CITY OF COLLEGE PARK, MARYLAND

Request for Bid Proposals CP-18-02

Hollywood Gateway Park Project – Addendum #3

March 14, 2018

DRAWN: DWK/2MB
 CHECKED: TJA
 DATE: 03/02/18
 PROJECT: 2012.03.00.00
 DRAWING: LD-1.00

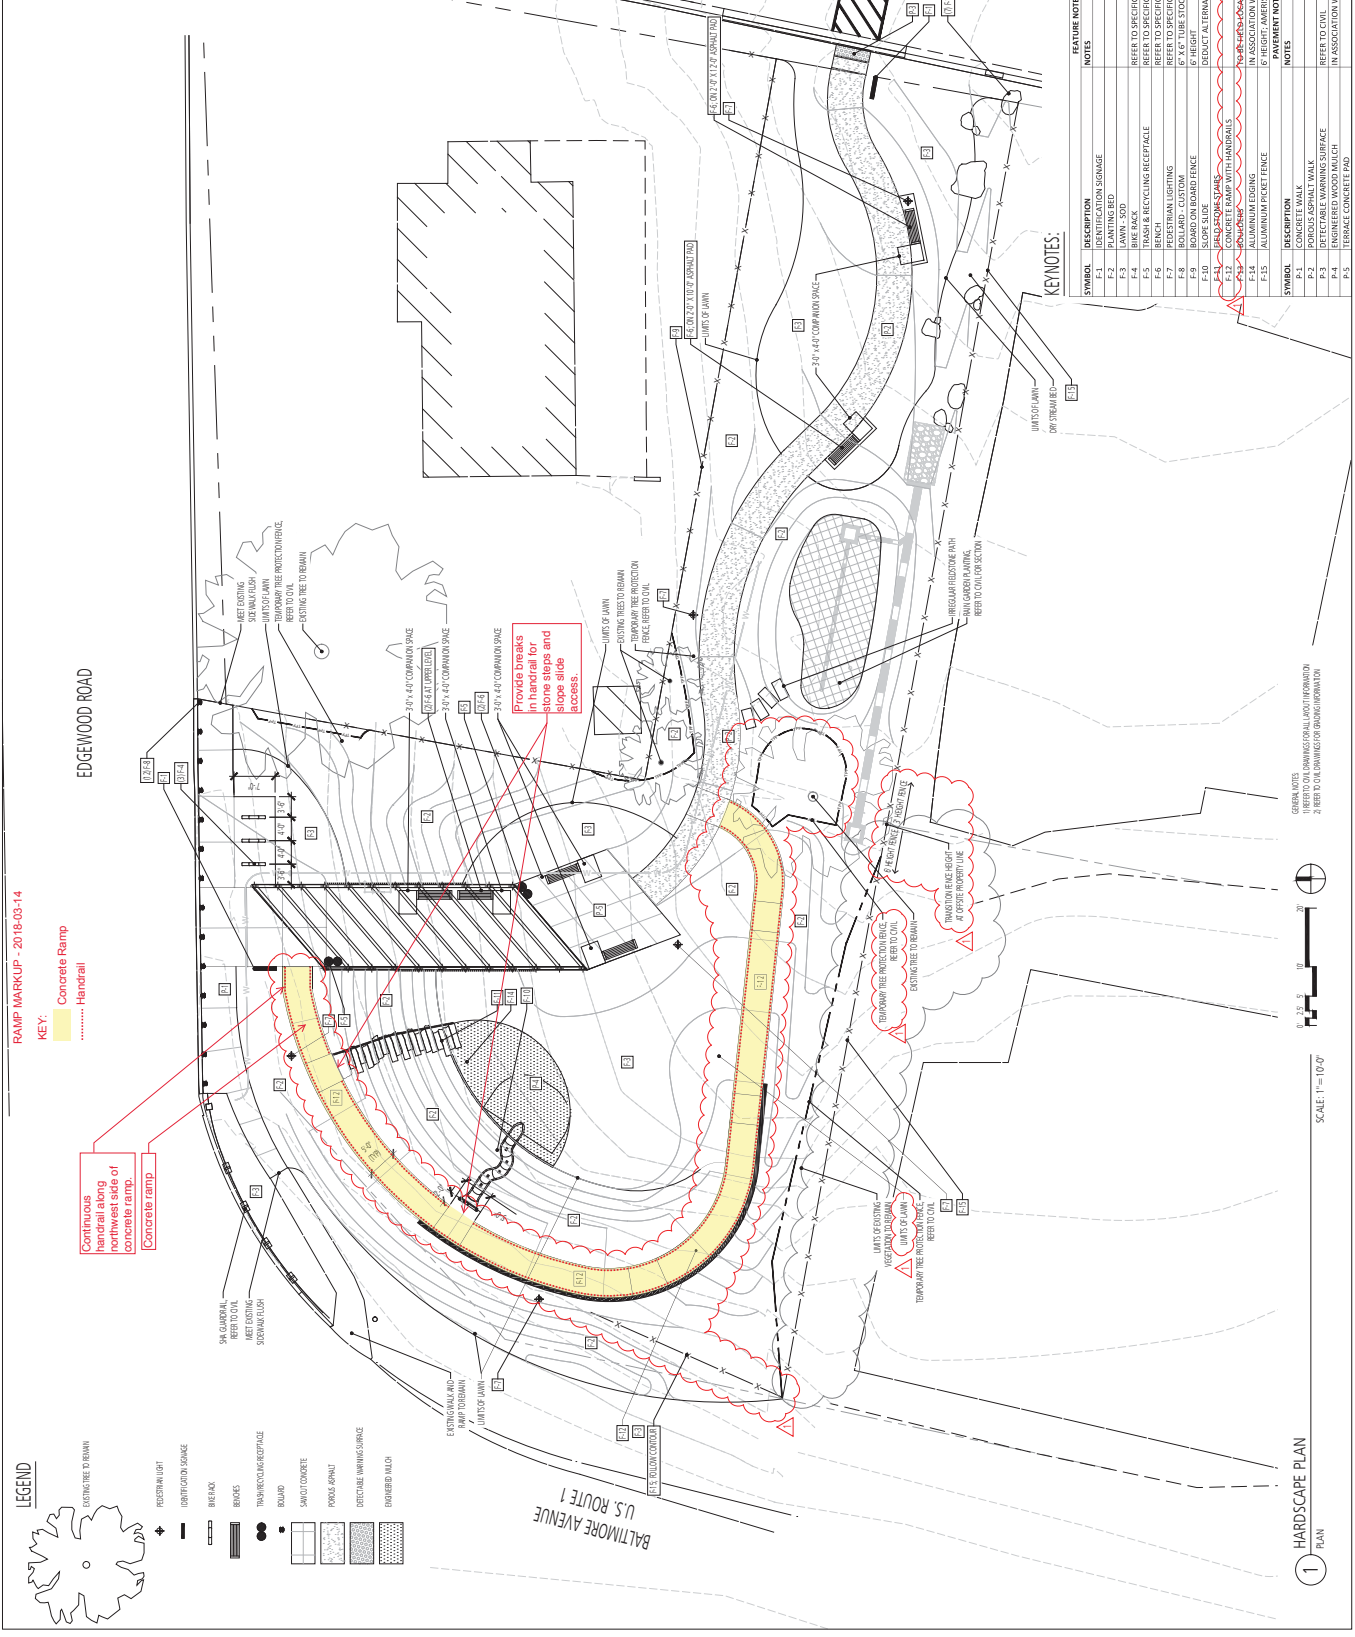
4. Q. In the Addendum I drawings, Note N-8 on sheet C-2.1 states, “New Concrete Ramp with Handrails.” This note is called out at all areas of concrete work including the “patio area” at the steel structure, and both of the sidewalks along the streets. As I believe the handrail portion of this note should only apply to the sloped ramp, could you clarify the extent of “handrail” required in note N-8?

A: The attached drawing will clarify the extent of the handrails. They are just along the linear ramped walks and landing except where discontinued for the fieldstone stairs and slope slide. The patio area and sidewalks along the streets are not included.
